DENVER AMENDMENT PROPOSAL FORM FOR PROPOSALS TO THE 2019 DENVER BUILDING CODE AMENDMENTS AND THE 2021 INTERNATIONAL CODES

2021 CODE DEVELOPMENT CYCLE

Code Sections/Tables/Figures Proposed for Revision:
1106.5 and subsections

Section IPC 1106.5 Parapet wall Scuppers *is replaced in its entirety as follows:*

Figure 1106.5

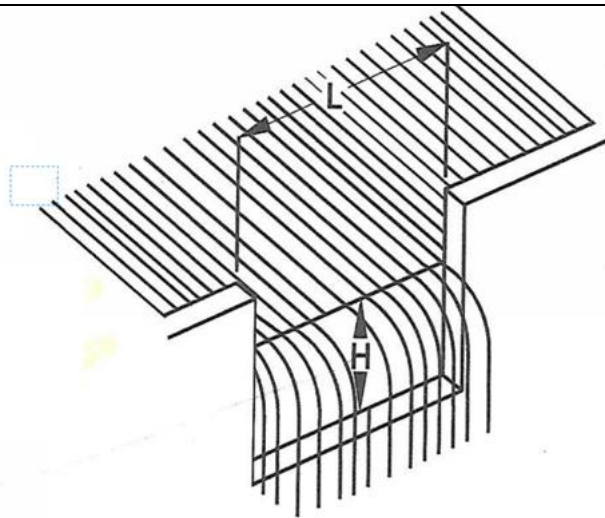
What circumference of the roof drain is to be used in determining the width of the scupper? The internal diameter of the roof drain piping? The diameter of the guard? Since roof drains are now sized based on the manufacturer's flow rate, the roof drain size (guard diameter and pipe diameter) can vary by manufacturer, which in turn, could change the minimum width of the scupper.

This revision clarifies that it is the size of the strainer circumference of the roof drain. An alternate method of using the well-known Francis Formula has been added as an option.

1106.5 Parapet wall scuppers. Where scuppers are used for primary roof drainage or for secondary (emergency over-flow) roof drainage or both, the quantity, size, location, and inlet elevation of the scuppers shall be chosen to prevent the depth of ponding water on the roof from exceeding the maximum water depth that the roof was designed for as determined by Section 1611.1 of the International Building Code. Scuppers shall have an opening height of not less than 4 inches (102 mm), a width of not less than 4 inches (102 mm) and shall be sized in accordance with 1106.5.1 or 1106.5.2. The flow through the primary system shall not be considered when locating and sizing secondary scuppers.

1106.5.2 Francis formula. The scupper shall be sized by the Francis formula given in Figure 1106.5.
